Alternative LTC Route Proposal  
(submitted by Robin Beard)

Please find attached my submission of an alternative route for the Lower Thames Crossing.

**Map 08 - Potentially dangerous weaving at the Orsett junction?**

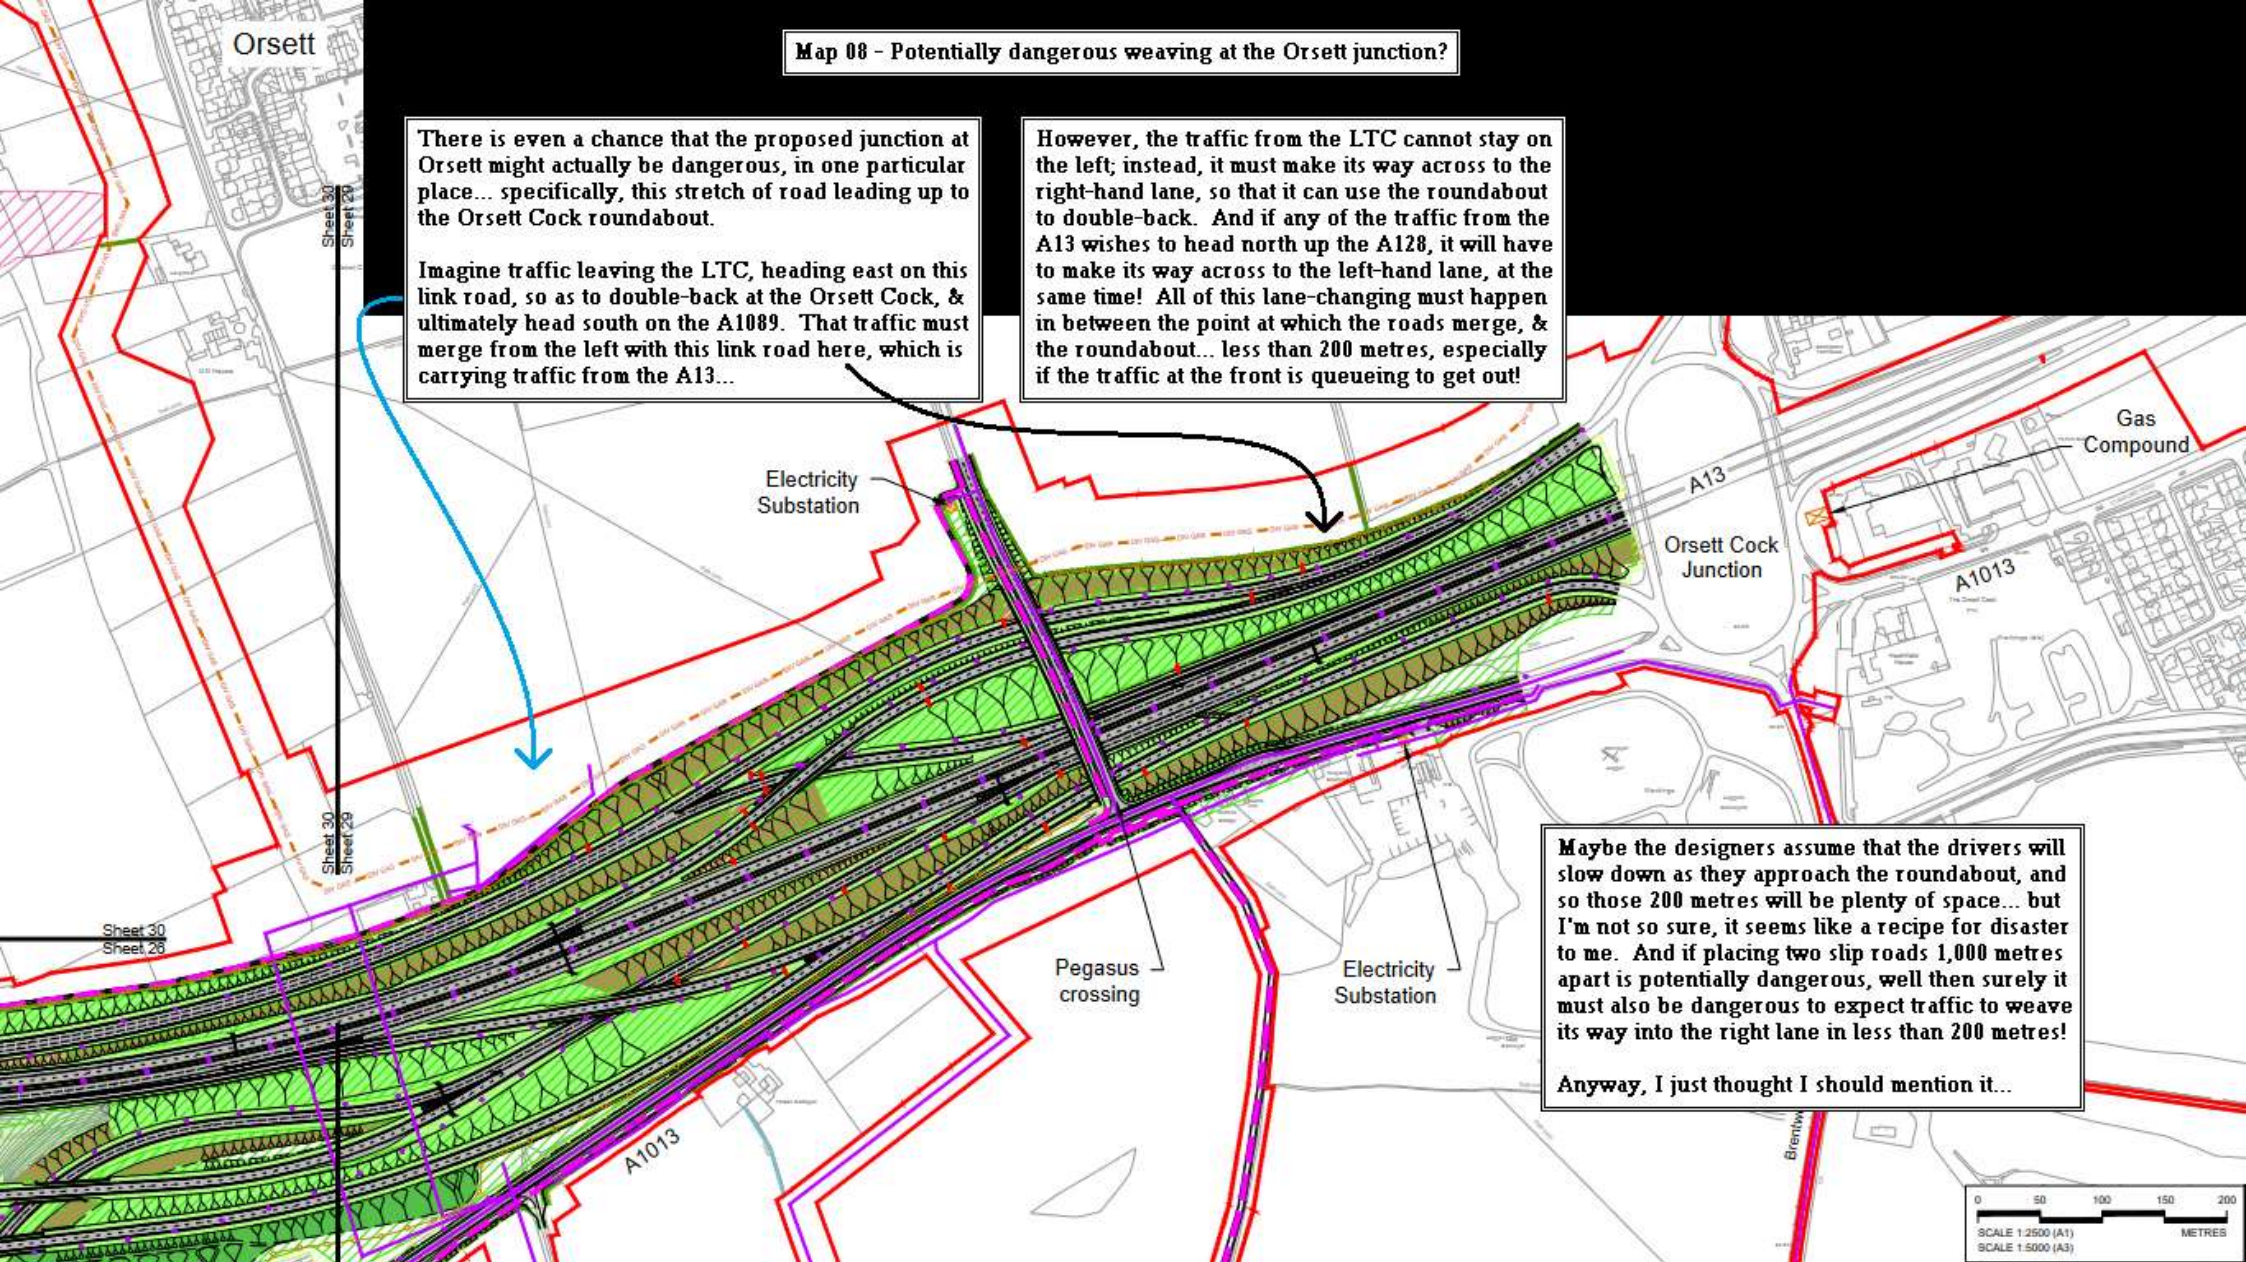
There is even a chance that the proposed junction at Orsett might actually be dangerous, in one particular place... specifically, this stretch of road leading up to the Orsett Cock roundabout.

Imagine traffic leaving the LTC, heading east on this link road, so as to double-back at the Orsett Cock, & ultimately head south on the A1089. That traffic must merge from the left with this link road here, which is carrying traffic from the A13...

However, the traffic from the LTC cannot stay on the left; instead, it must make its way across to the right-hand lane, so that it can use the roundabout to double-back. And if any of the traffic from the A13 wishes to head north up the A128, it will have to make its way across to the left-hand lane, at the same time! All of this lane-changing must happen in between the point at which the roads merge, & the roundabout... less than 200 metres, especially if the traffic at the front is queueing to get out!

Maybe the designers assume that the drivers will slow down as they approach the roundabout, and so those 200 metres will be plenty of space... but I'm not so sure, it seems like a recipe for disaster to me. And if placing two slip roads 1,000 metres apart is potentially dangerous, well then surely it must also be dangerous to expect traffic to weave its way into the right lane in less than 200 metres!

Map 09 - The Orsett Fen

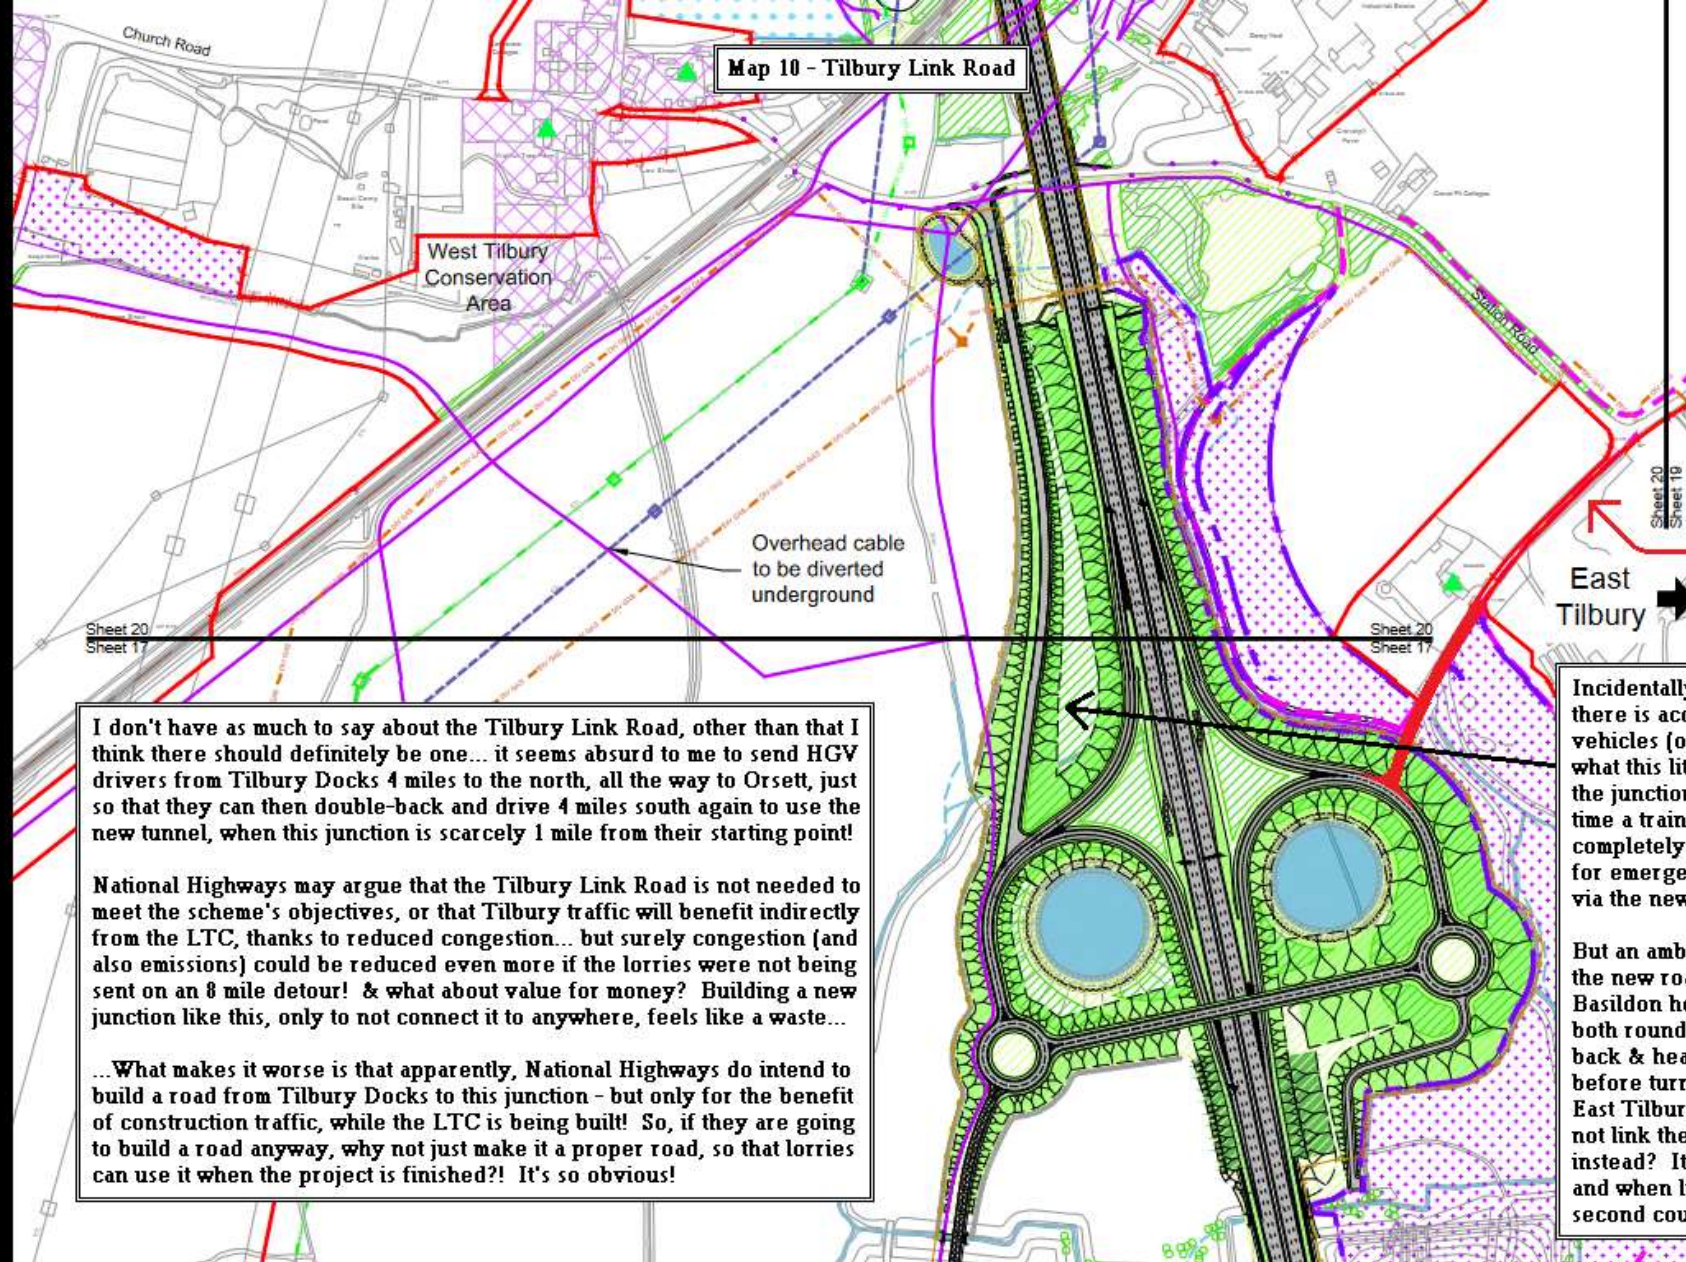
The green and yellow patches indicate the land that is at risk of flooding; and where the LTC crosses this region, the designers have seen fit to elevate the road above ground level, to ensure that it will remain high & dry at all times. But as you can see, in order to accomplish this, their design requires the construction of 3 embankments, and 2 viaducts, each of which is hundreds of metres long... with the total length of the elevated section being more than a mile.

And all of this is only necessary because the route that National Highways have selected takes the LTC straight across the very middle of the Orsett Fen... it is difficult to imagine a more flood-prone route! But with the LTC approaching from the south like this, National Highways had no choice but to come this way... & so time and money must be wasted on lengthy embankments and viaducts, just to defend against the forces of nature.

And over here we see the field through which I would run the new road, with its conspicuous tongue of dry ground protruding deep into the flood risk area, almost as far as to the banks of the Mardyke itself!

If the LTC approached from the east as shown here, it would effectively cross the Mardyke's flood plain at its narrowest point, thus slashing the required length of the elevated section by at least 50%... it could save millions of pounds, & may even shave months off the construction time as well. The environmental impact would also be reduced...

(Full disclosure - the flood risk area extends off the map to the east here, where my route crosses it a second time; but it tapers to such a narrow point that it shouldn't even require a viaduct, a single bridge should suffice.)

**Map 12 - My alternative route, with free-flowing connections**

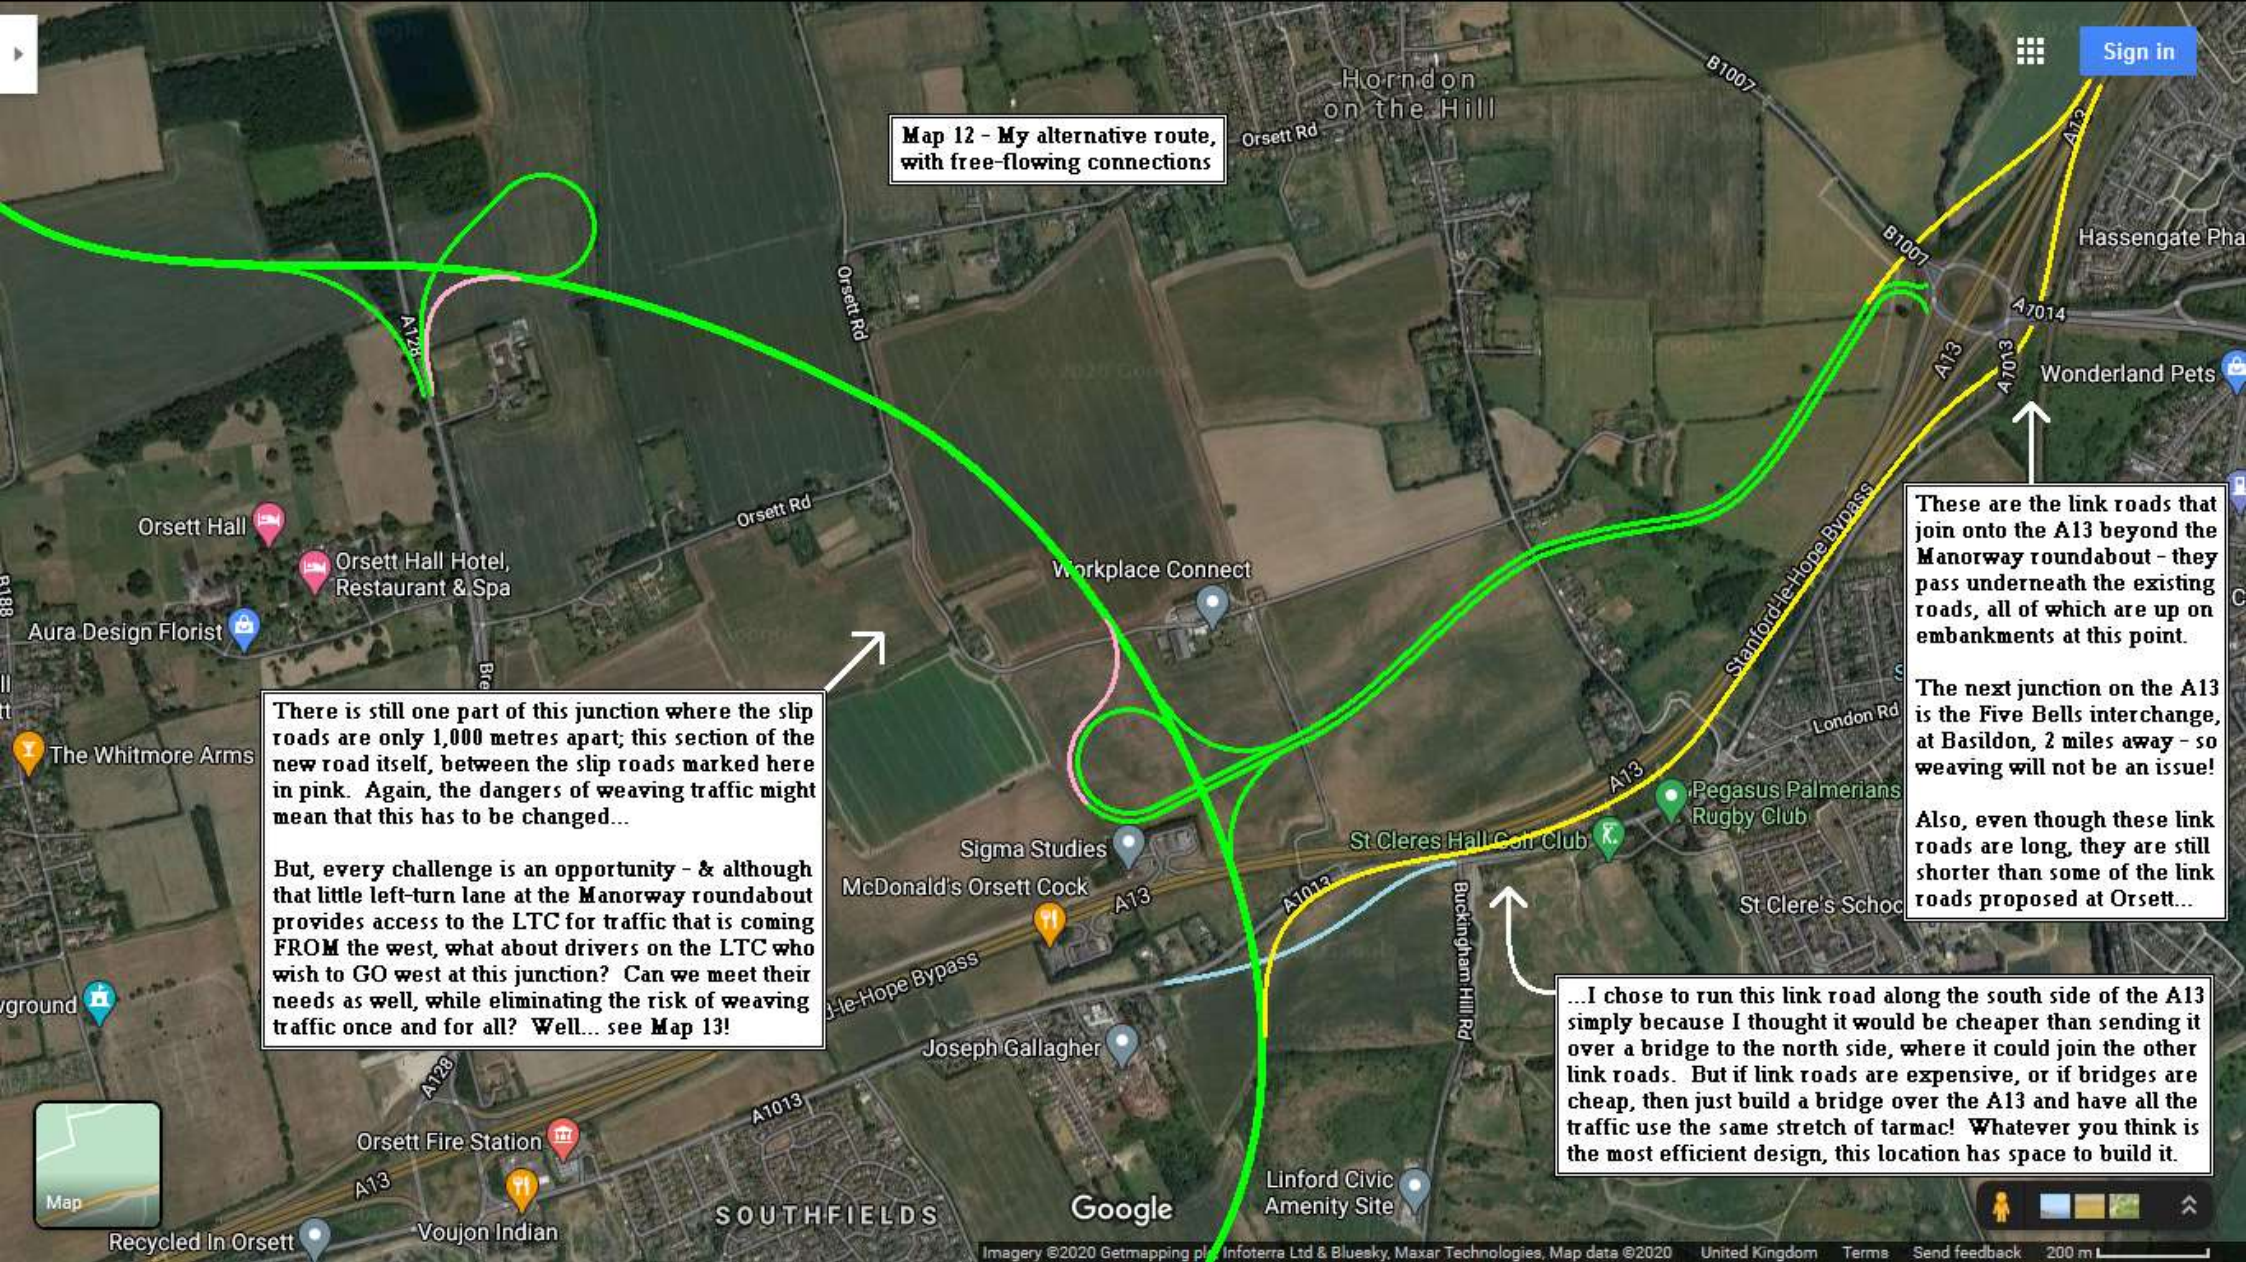
There is still one part of this junction where the slip roads are only 1,000 metres apart; this section of the new road itself, between the slip roads marked here in pink. Again, the dangers of weaving traffic might mean that this has to be changed...

But, every challenge is an opportunity - & although that little left-turn lane at the Manorway roundabout provides access to the LTC for traffic that is coming FROM the west, what about drivers on the LTC who wish to GO west at this junction? Can we meet their needs as well, while eliminating the risk of weaving traffic once and for all? Well... see Map 13!
